CITY OF ALBUQUERQUE

Sites: Coors Pavilion Subdivision - 4111 Coors Blvd NW -

Re: Drainage Ordinance (14-5-2-11) Violations for Erosion and Sediment Control

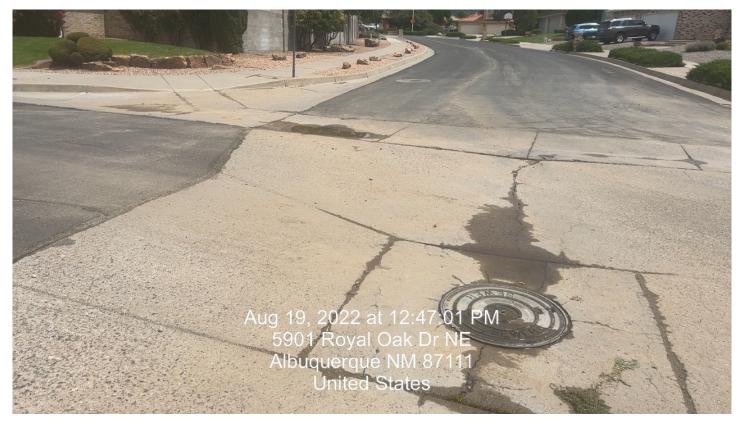
Piles of sediment begin inside the private gated community at McKay Way,

with tracks leading all of the way to the intersection of Spain and Royal Oak Dr.

1. Where sediment has been tracked-out from your site onto paved roads and sidewalks remove the deposited sediment by the end of the same business day CGP 2.2.4.d, and implement additional track-out controls as necessary to ensure that sediment removal occurs prior to vehicle exit CGP 2.2.4.c.
